| | Addendum to the Final Environmental Impact Statement - Baffinland Response to Technical Comments November 15, 2013 | | |
| | Qikiqtani Inuit Association | Baffinland's Response | |

Figure 1: Caribou decision tree

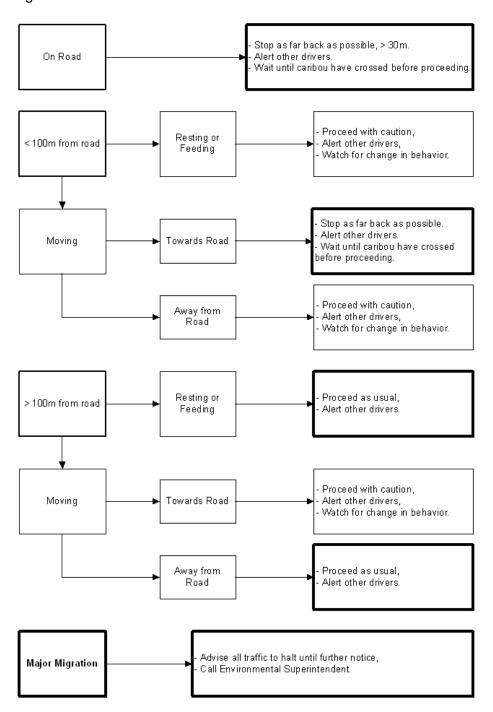
The Proponent must re-evaluate the potential impact on caribou movement of upwards of 200 trucks per day, the majority of them haul trucks, travelling along the Tote Road for the life of the mine. This re-evaluation should include revisions to the mitigation and adaptive monitoring plans and an assessment of residual impacts after mitigation.

The Roads Management Plan should specify how caribou presence on and in the vicinity will be monitored and what thresholds (other than the tracks) will be used to trigger specific levels of traffic management. Baffinland should investigate dash camera technology and wildlife road surveillance systems to prevent collisions and use remote camera monitoring to describe caribou use of the road corridor.

- Modified embankment heights and finer fill material at trails that cross the road (e.g., caribou crossings);
- Snow bank height maintained at less than 1 m;
- Operator radio communication as an early warning of caribou to approaching vehicles;
- Road signage identifying known crossing areas;
- Wildlife right-of-way policy; and
- Implementation of the caribou decision tree (see attachment).

QIA's suggestion for dash-mount cameras is not being considered as a monitoring tool. Communication among drivers, check-in at gates for wildlife observations, height-of-land surveys and follow-up investigations of all mortality events are sufficient to monitor and mitigate potential effects on caribou movement.
